**PLANNED UNIT DEVELOPMENT
& SUBDIVISION STAFF REPORT****Date: May 1, 2014****DEVELOPMENT NAME**

Tilcor Subdivision

CONTEMPLATED USEPlanned Unit Development approval to allow shared access
between two building sites, and Subdivision approval to create two legal lots from one metes and
bounds parcel.**TIME SCHEDULE
FOR DEVELOPMENT**

SITE PLAN

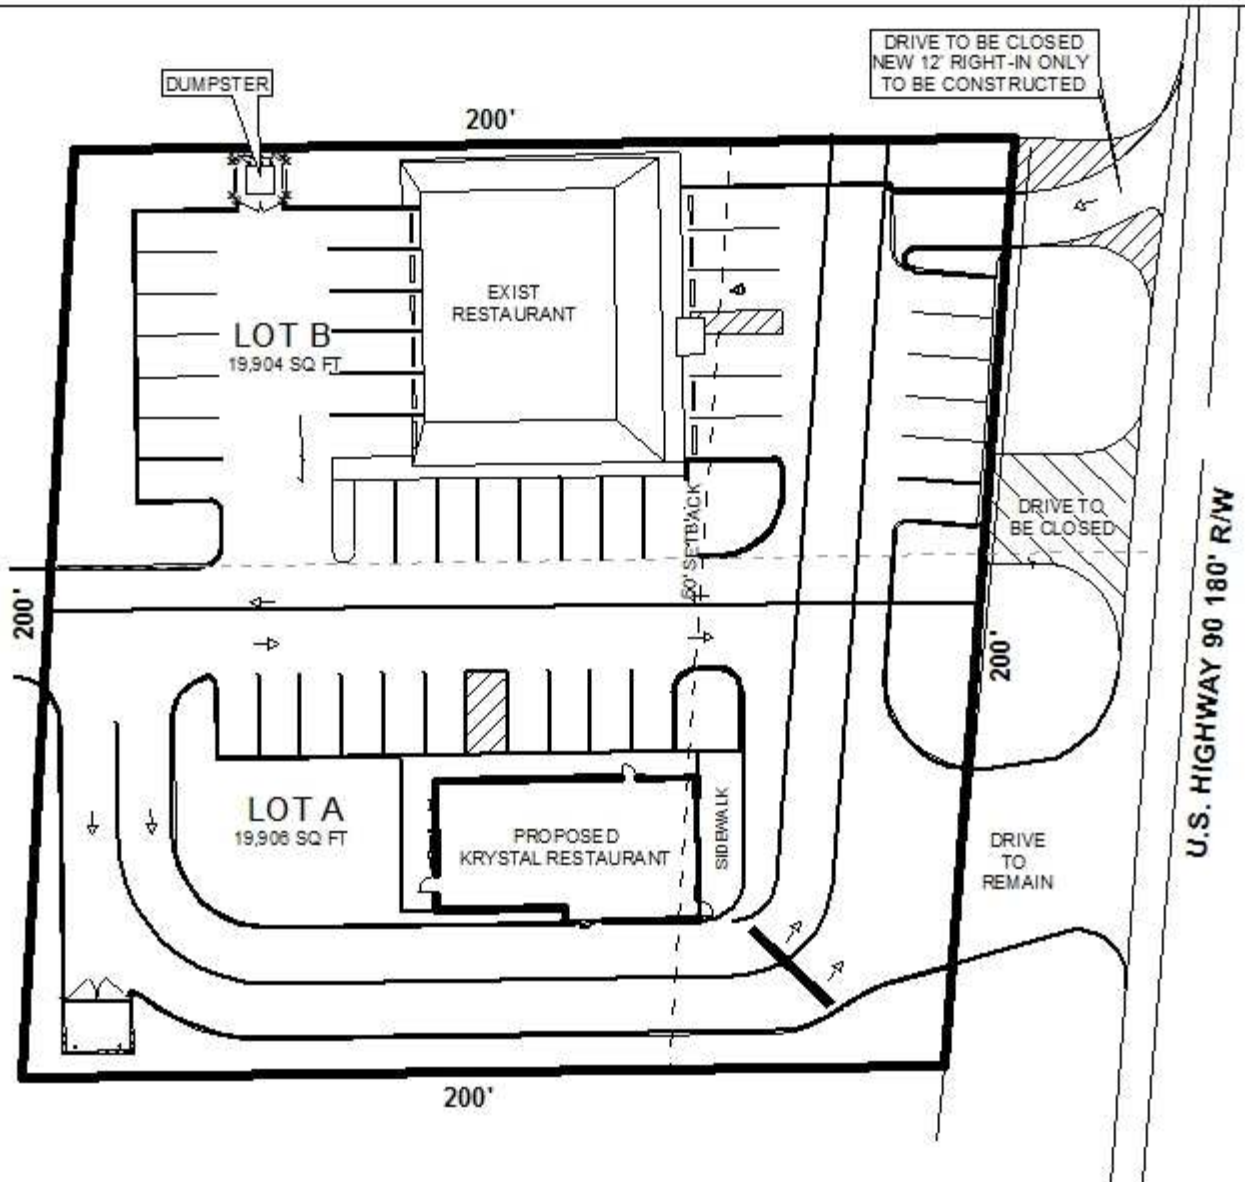
It should be noted there is a discrepancy between the revised 2-lot subdivision plat and the site plan. The site plan depicts the entire site as Lot A, but illustrates a dashed line through the lot indicating one portion of the site as 111' wide and the other portion as 89' wide. The preliminary plat depicts the site as Lot A and Lot B with both proposed lots being 100' wide each. Also, the site plan does not reflect the 60' minimum building setback line as illustrated on the preliminary plat. A revised site plan should be submitted to address the inconsistency between the preliminary plat and the site plan.

The applicant has submitted a site plan illustrating the placement of the buildings, dumpster locations, and landscaping; however, the illustration of frontage trees and perimeter trees are not depicted on the site plan. The site plan should be revised to depict the lot sizes in square feet and acres, provide the frontage and total landscaping calculations, and the total number of frontage trees and perimeter trees. A total of 29 trees, to include: 6 frontage trees, 20 perimeter trees, and 3 parking trees will be required. A revised site plan will be required prior to issuance of any permits for the site, and prior to the signing of the Final Plat.

The site plan depicts a total of 43 parking spaces for the entire site. The entire site is required to provide 38 parking spaces due to the existing and proposed restaurant uses. However, the site is proposed as 2 separate lots which would require Lot B to provide 21 parking spaces and Lot A to provide 17 parking spaces: Lot A does not have enough parking spaces to accommodate 17 vehicles, thus shared parking will be needed. A revised narrative requesting shared access as well as shared parking will be required.

It should be noted there is only one handicap space indicated and striped on the site plan, in front of the existing restaurant. The accessible parking space and access aisle is 14' wide, which is not wide enough to accommodate a handicap accessible van. The site plan illustrates a second striped area, however, there is no designated handicap accessible space indicated on the plan.

The proposed second building is a restaurant with a drive-thru. Section 64-4.F.2 of the Zoning Ordinance addresses design standards for drive-thru business. All queuing spaces must be 9 feet wide by 20 feet long. Each drive-thru lane must provide a minimum of 3 queuing spaces between the order station and the service window, and a minimum of 3 queuing spaces from the street right-of-way to the service window. The site plan does not illustrate queuing spaces nor does it illustrate the location of a menu board and service window. A revised site plan to illustrate the locations of the menu board(s), service window(s), and queuing spaces will be required.

The site plan fails to illustrate the location of proposed signage. While each lot will be a separate legal lot of record, which will allow 1 freestanding sign, 1 multitenant sign, and 1 wall sign for each business. If the applicants wish to deviate from the standard sign allowance, sign information must be included with the site plan requesting the total number of signs for each business and illustrating the locations of the signs. All proposed signage must be depicted on the site plan.

Two dumpsters are depicted on the site plan and do appear to be enclosed on all three sides. However, there is no indication that the dumpster will be connected to sanitary sewer. The site plan should be revised to indicate if the dumpsters will be connected to sanitary sewer. It should also be noted, when submitting for a building permit, detailed plans illustrating the dumpster within a wooden or brick enclosure of at least 6 feet, but not to exceed 8 feet, in height will be required.

A sidewalk will be required for the proposed development, thus the site plan should be revised to depict a sidewalk along U.S. Highway 90, or an application for a sidewalk waiver should be submitted prior to the approval of any permits.

- 1) revise the site plan to reflect the preliminary plat to include the total number of lots and the dimensions of the lots;
- 2) revise the site plan to depict the 60' minimum building setback line;
- 3) placement of a note on the site plan stating the site is limited to a total of 2 curb-cuts to U.S. Highway 90 West, with the size, design and location to be approved by Traffic Engineering, ALDOT, and in conformance with AASHTO standards.;

- 4) revise the site plan to depict the lot sizes in square feet and acres;
- 5) revise the site plat to provide the landscaping frontage and total landscaping calculations;

- 6) revise the site plan to depict frontage trees and perimeter trees;
- 7) submission of a revised narrative requesting shared access as well as shared parking;

- 8) revise the site plan to illustrate the location of the menu board(s), service window(s), and queuing spaces;
- 9) retention of dumpsters on the site plan;

- 10) placement of a note on the site plan stating dumpsters will be enclosed on all three sides and connected to sanitary sewer;
- 11) retention of 24' wide drive aisles as depicted on site plan;

- 12) revise the site plan to depict the location of wall and freestanding signage for the site;
- 13) revise the site plan to depict sidewalk along U.S Highway 90, or submit a sidewalk waiver request;
